BROWNS FERRY NUCLEAR PLANT (BFN) - UNITS 2 and 3 - TECHNICAL SPECIFICATIONS (TS) CHANGE TS-441 - UPDATE OF PRESSURE-TEMPERATURE (P-T) CURVES

PROPOSED TECHNICAL SPECIFICATIONS (TS) CHANGE TS-441 TVA EVALUATION OF PROPOSED CHANGE

**PROPOSED TECHNICAL SPECIFICATIONS (TS) CHANGE TS-441
MARKED PAGES**

PROPOSED TECHNICAL SPECIFICATIONS (TS) CHANGE TS-441
REVISED PAGES

Figure 3.4.9-1
Pressure/Temperature Limits

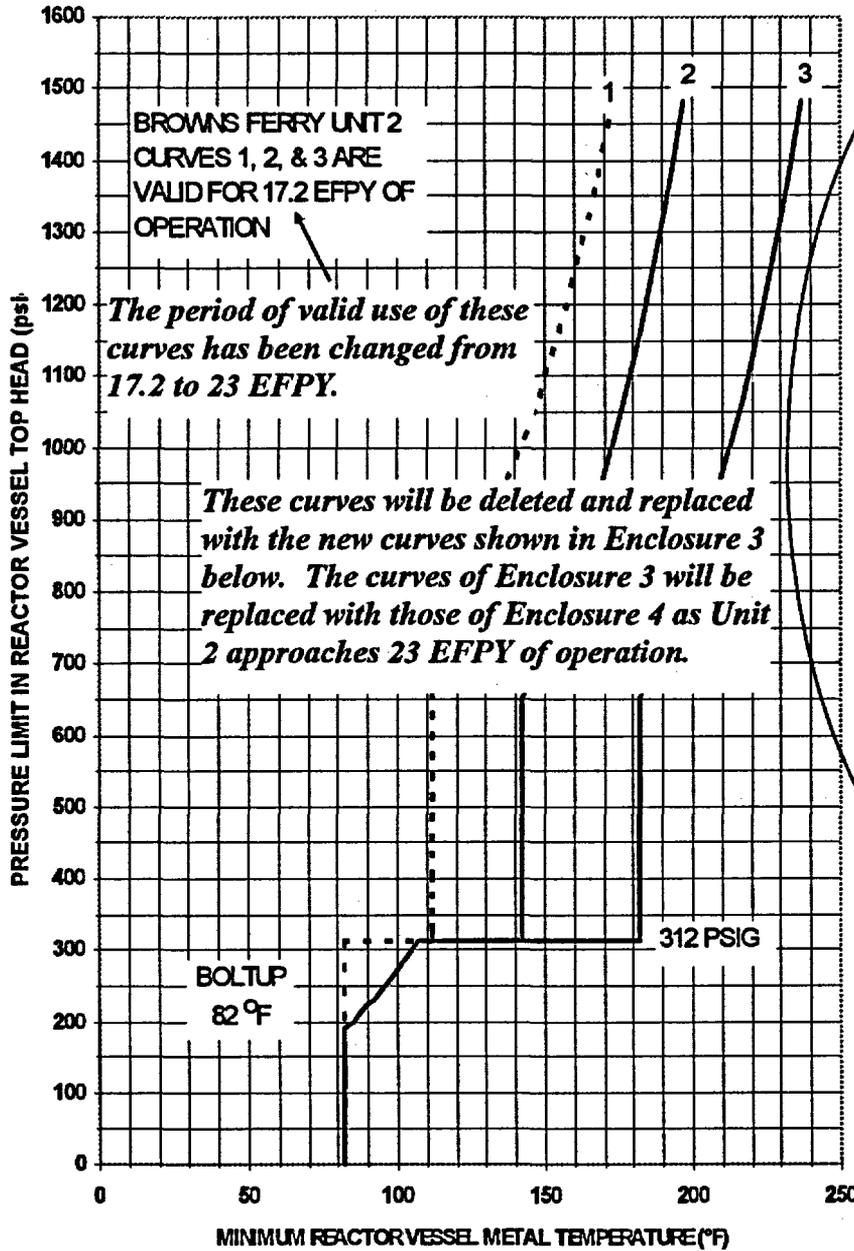
Curve Legends have been revised on new TS pages to include the additional curves, their applicability, and the new Unit 2 valid EFPY interval of 23 years

Notes
These curves include sufficient margin to provide protection against feedwater nozzle degradation. The curves allow for shifts in RT_{NDT} of the Reactor vessel bellline materials, in accordance with Reg. Guide 1.99, Rev. 2, to compensate for radiation embrittlement for 17.2 EFPY.

1. TS Figure 3.4.9-1 for Unit 2 and Unit 3 is deleted and replaced in its entirety.
2. The new TS Figure 3.4.9-1 contains an added curve which specifically details reactor vessel bottom head temperature versus pressure limitations for non-critical heatup/cooldown operational conditions.
3. A new TS Figure 3.4.9-2 has been added which contains curves for the reactor vessel bottom head and the upper vessel/beltline regions for in-service leak and hydrostatic testing activities.

Figure 3.4.9-1
Pressure/Temperature Limits

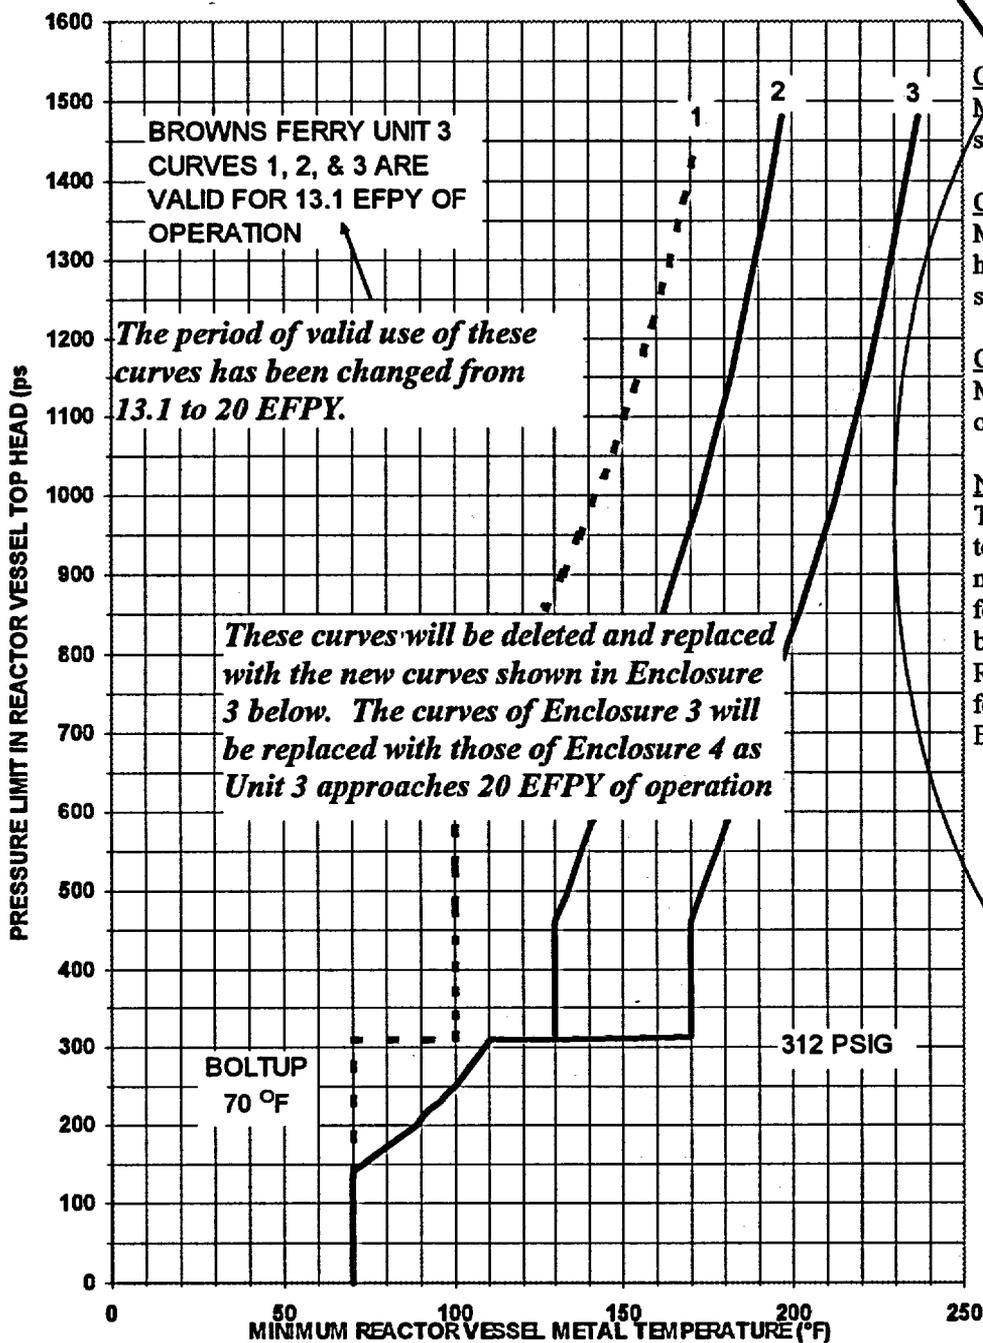
Curve Legends have been revised on new TS pages to include the additional curves, their applicability, and the new Unit 3 valid EFPY interval of 20 years

Notes
These curves include sufficient margin to provide protection against feedwater nozzle degradation. The curves allow for shifts in RT_{NDT} of the Reactor vessel beltline materials, in accordance with Reg. Guide 1.99, Rev. 2, to compensate for radiation embrittlement for 13.1 EFPY.

Figure 3.4.9-1
Pressure/Temperature Limits for
Mechanical Heatup, Cooldown following Shutdown, and
Reactor Critical Operations

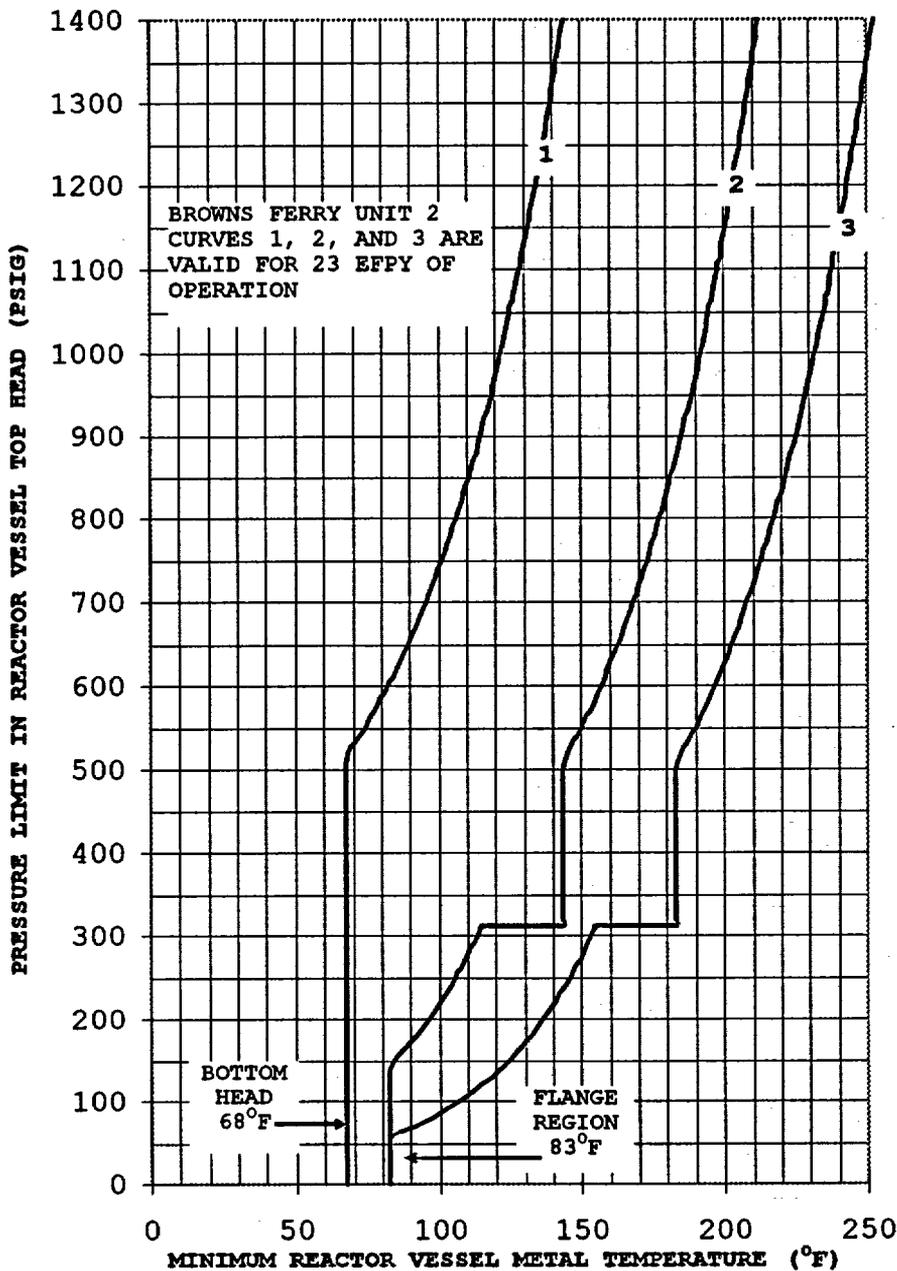
Notes
These curves include sufficient margin to provide protection against feedwater nozzle degradation. The curves allow for shifts in RT_{NDT} of the Reactor vessel beltline materials, in accordance with Reg. Guide 1.99, Rev. 2, to compensate for radiation embrittlement for 23 EFPY.

Figure 3.4.9-1
Pressure/Temperature Limits for
Mechanical Heatup, Cooldown following Shutdown, and
Reactor Critical Operations

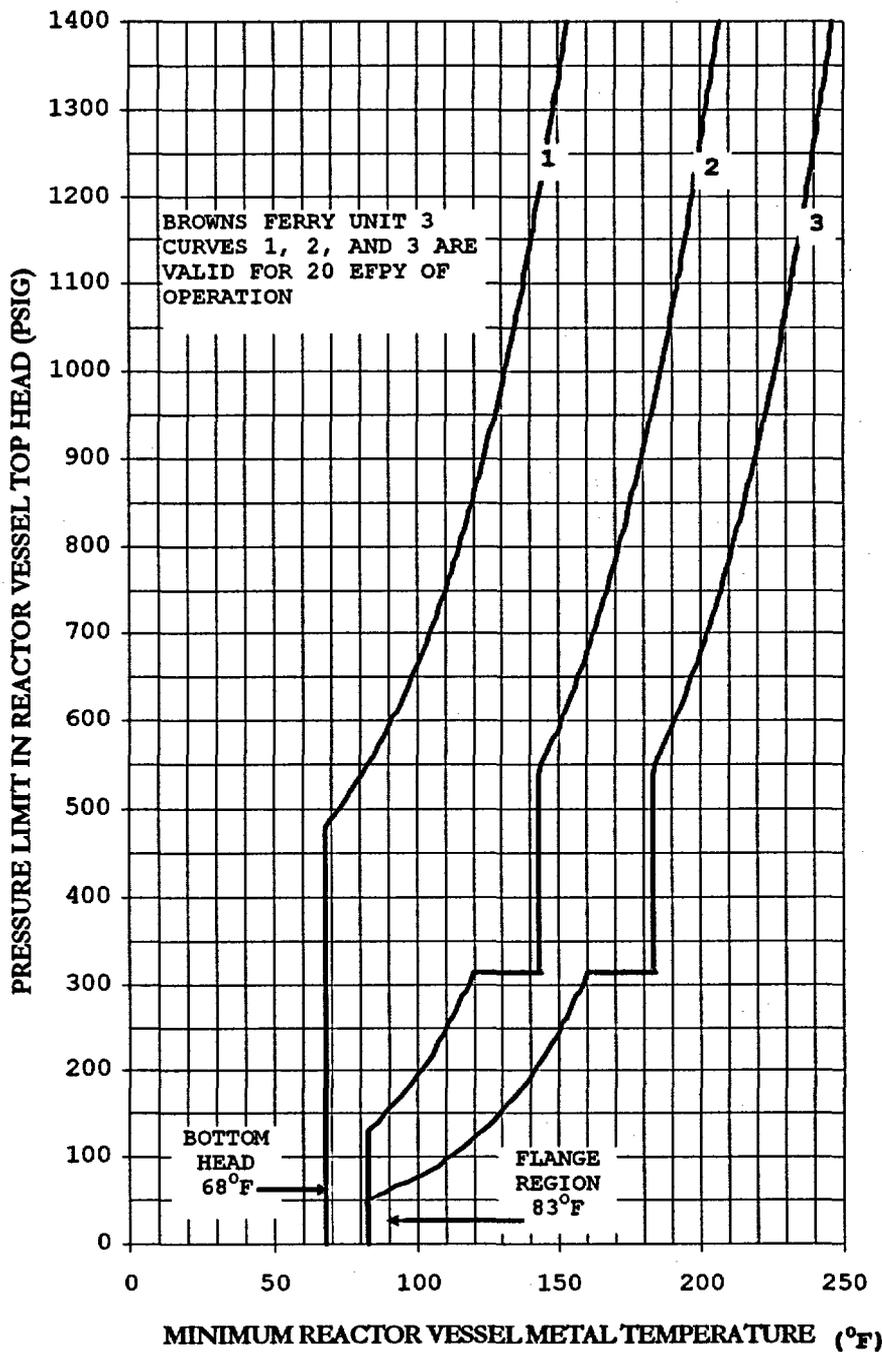
Notes
These curves include sufficient margin to provide protection against feedwater nozzle degradation. The curves allow for shifts in RT_{NDT} of the Reactor vessel beltline materials, in accordance with Reg. Guide 1.99, Rev. 2, to compensate for radiation embrittlement for 20 EFPY.

Figure 3.4.9-2
Pressure/Temperature Limits for
Reactor In-Service Leak and Hydrostatic Testing

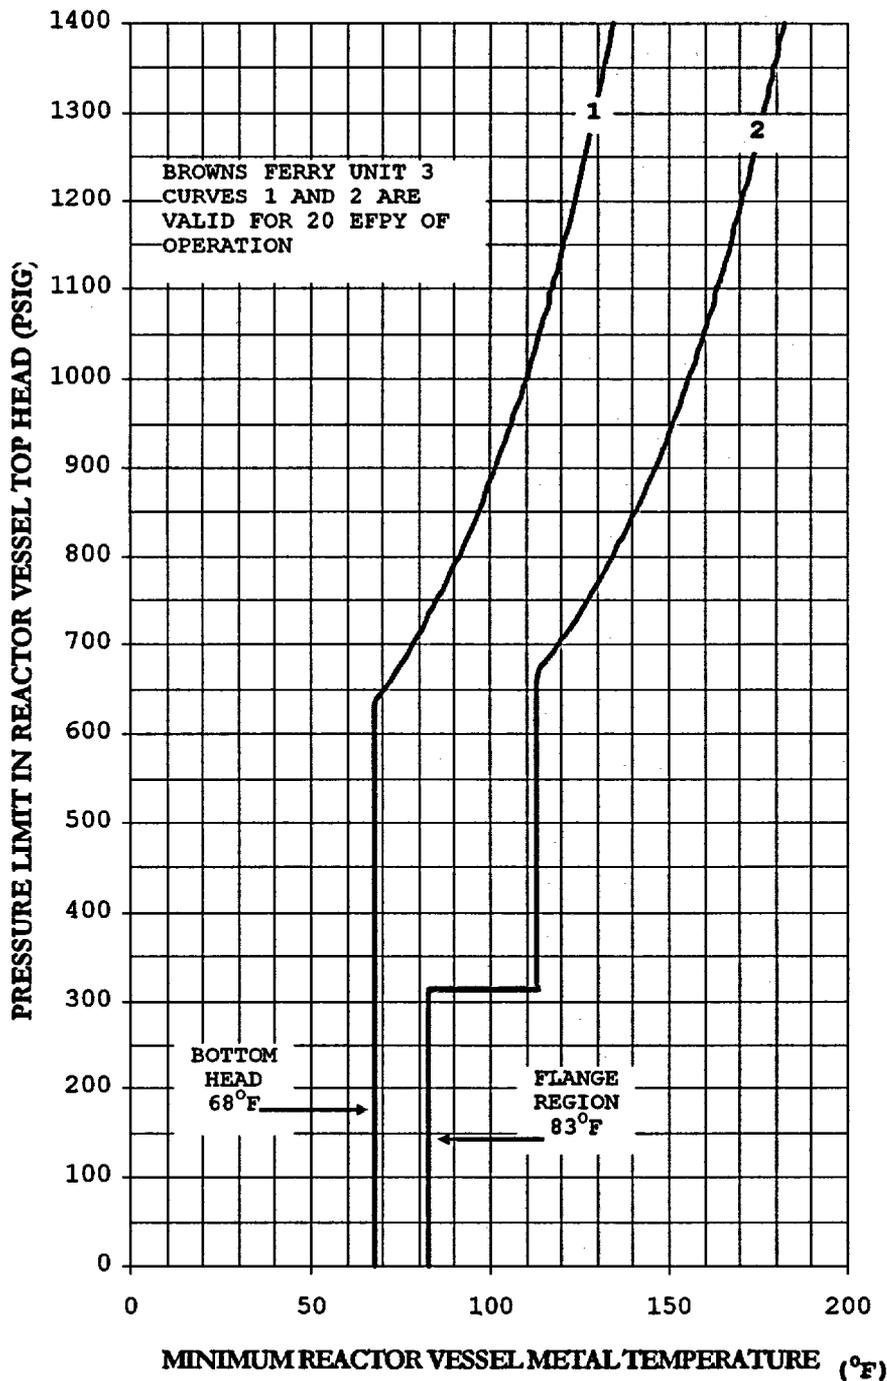
Notes
These curves include
sufficient margin to
provide protection against
feedwater nozzle
degradation. The curves
allow for shifts in RT_{NDT}
of the Reactor vessel
beltline materials, in
accordance with Reg. Guide
1.99, Rev. 2, to
compensate for radiation
embrittlement for 20 EFPY.

Figure 3.4.9-1
Pressure/Temperature Limits for Mechanical Heatup, Cooldown following Shutdown, and Reactor Critical Operations

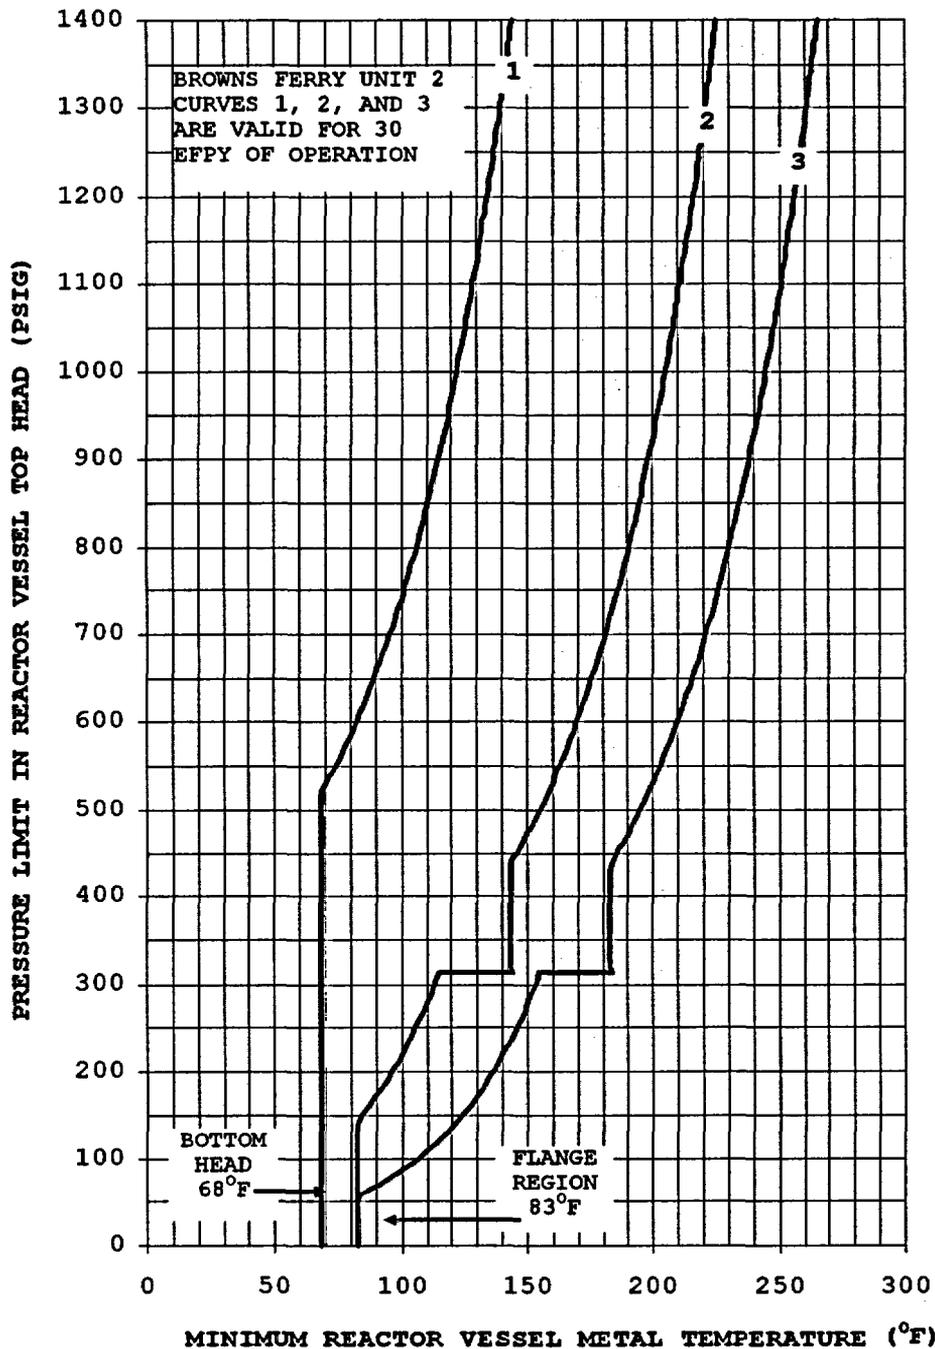
These pages are submitted for NRC review and approval, however, they will not be placed into the BFN TS at this time. As Unit 2 approaches 23 EFPY, and as Unit 3 approaches 20 EFPY, TVA will replace the TS figures shown in Enclosure 3 above with these figures.

Notes
These curves include sufficient margin to provide protection against feedwater nozzle degradation. The curves allow for shifts in RT_{NDT} of the Reactor vessel beltline materials, in accordance with Reg. Guide 1.99, Rev. 2, to compensate for radiation embrittlement for 30 EFPY.

Figure 3.4.9-2
Pressure/Temperature Limits for
Reactor In-Service Leak and Hydrostatic Testing

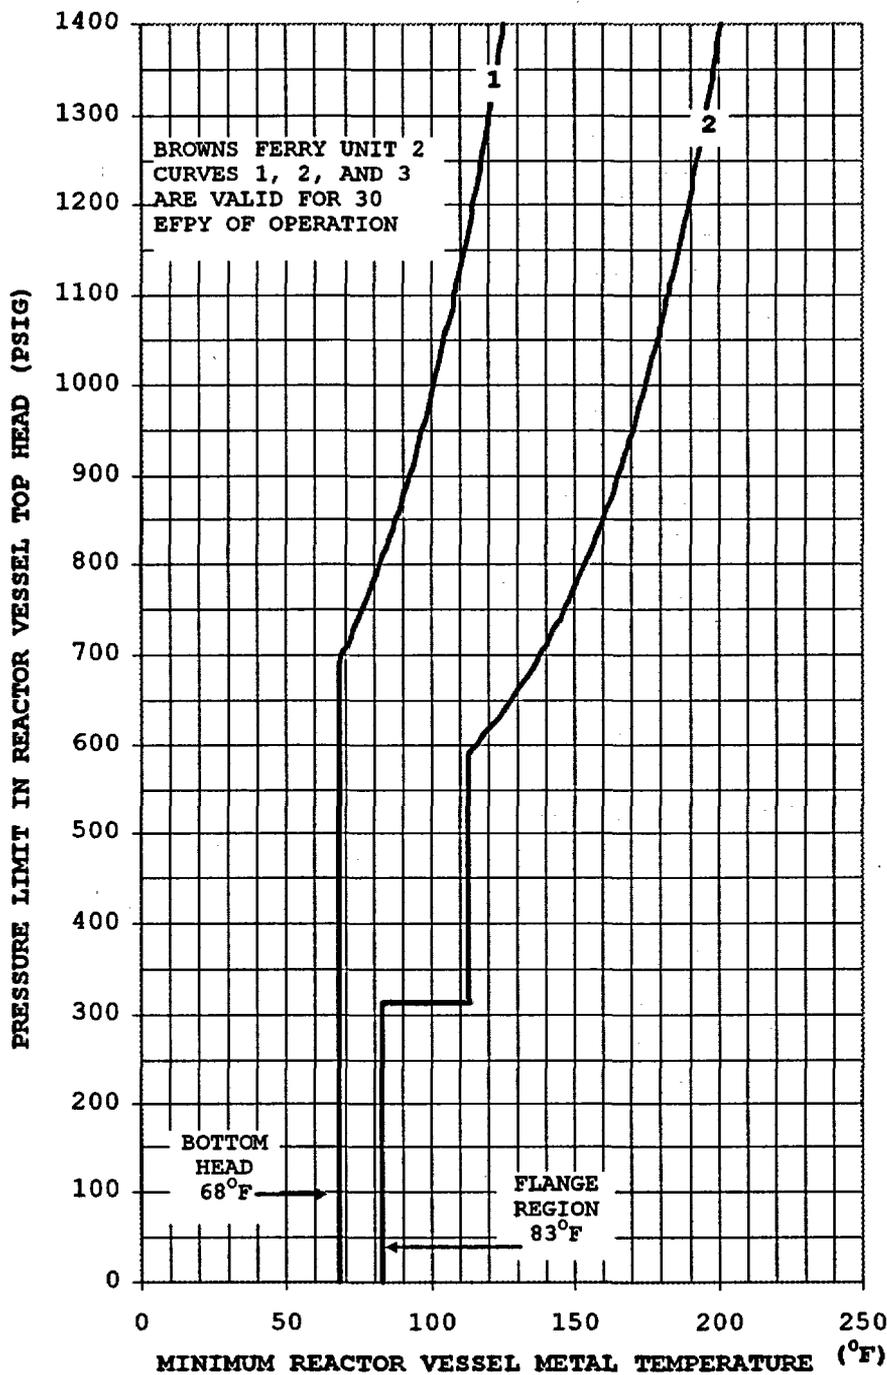
Notes
These curves include
sufficient margin to
provide protection against
feedwater nozzle
degradation. The curves
allow for shifts in RT_{NDT}
of the Reactor vessel
beltline materials, in
accordance with Reg. Guide
1.99, Rev. 2, to
compensate for radiation
embrittlement for 30 EFPY.

Figure 3.4.9-1
Pressure/Temperature Limits for Mechanical Heatup, Cooldown following Shutdown, and Reactor Critical Operations

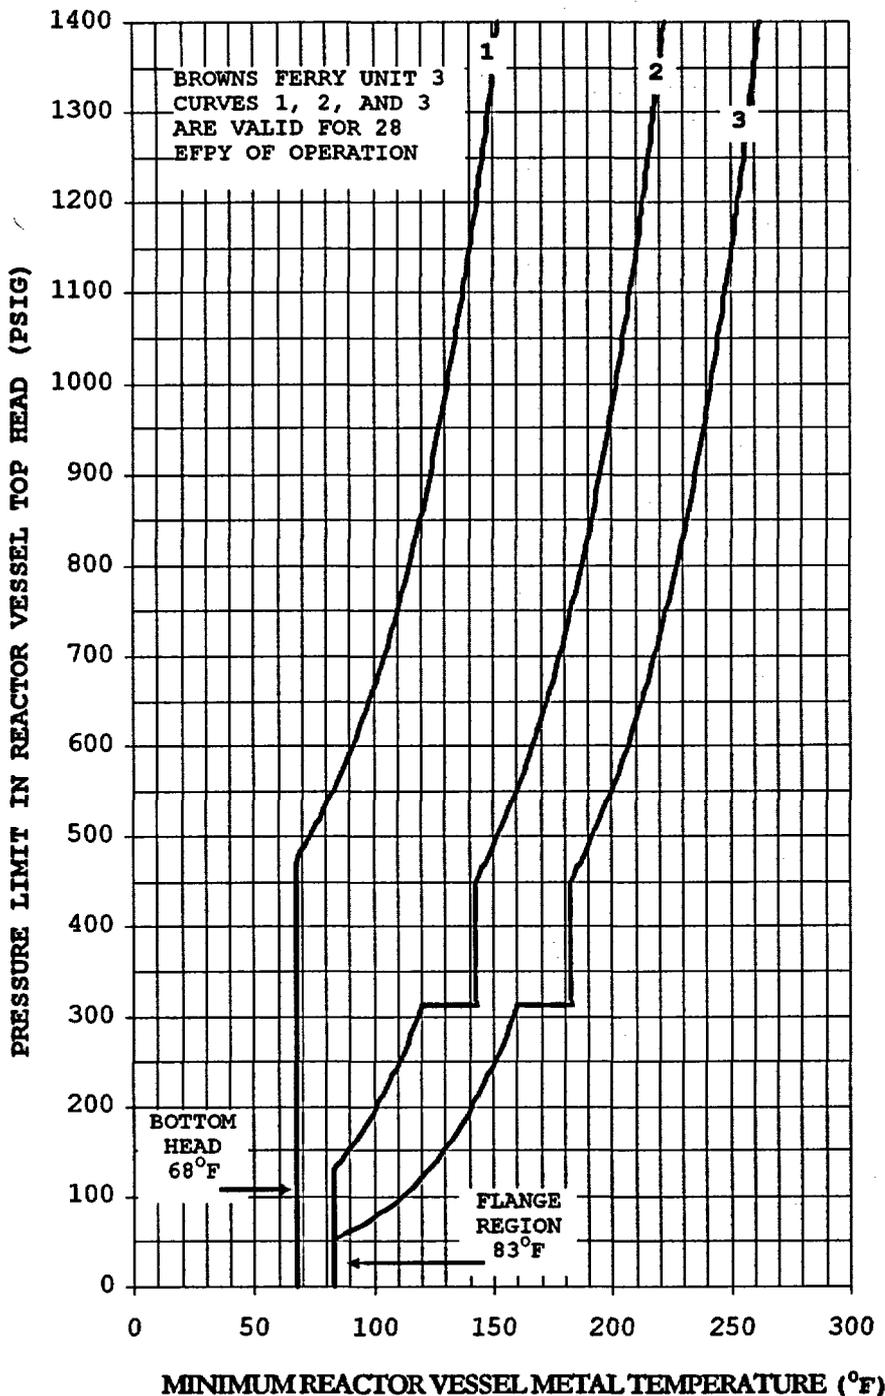
Notes
These curves include sufficient margin to provide protection against feedwater nozzle degradation. The curves allow for shifts in RT_{NDT} of the Reactor vessel beltline materials, in accordance with Reg. Guide 1.99, Rev. 2, to compensate for radiation embrittlement for 28 EFPY.
